Ref:	NR/L2/ELP/27009/MOD C06
Issue:	1
Date:	03/12/2011
Compliance date:	03/03/2012
Page	1 of 2

OVERHEAD LINE CAMPAIGN CHANGES – DATA SHEET

REPLACEMENT OF ILLEGIBLE STRUCTURE NUMBER PLATES (SELF ADHESIVE PLASTIC TYPES)

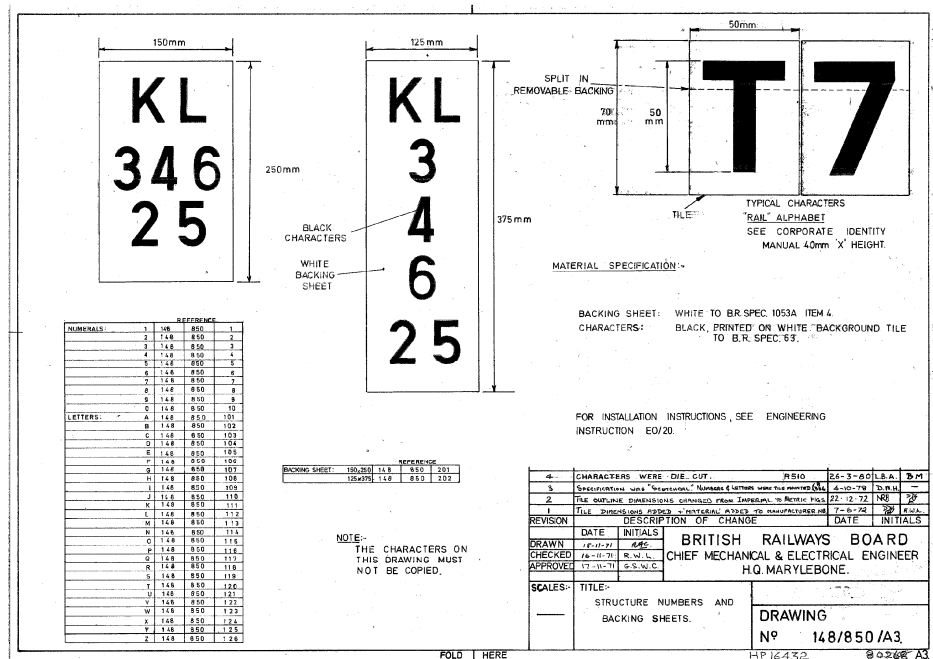
PROBLEM Illegible structure number plates lead to lost time due to inaccurate location reports of incidents or defects; this is also a safety issue due to incorrect identification of switching or earth locations.

OVERHEAD LINE CAMPAIGN CHANGES – DATA SHEET	
06	REPLACEMENT OF ILLEGIBLE STRUCTURE NUMBER PLATES (SELF ADHESIVE PLASTIC TYPES)
ACTION REQUIRED	<p>1. Replace the illegible structure number plates with die pressed aluminium plates to drawing 1/148/812.</p>
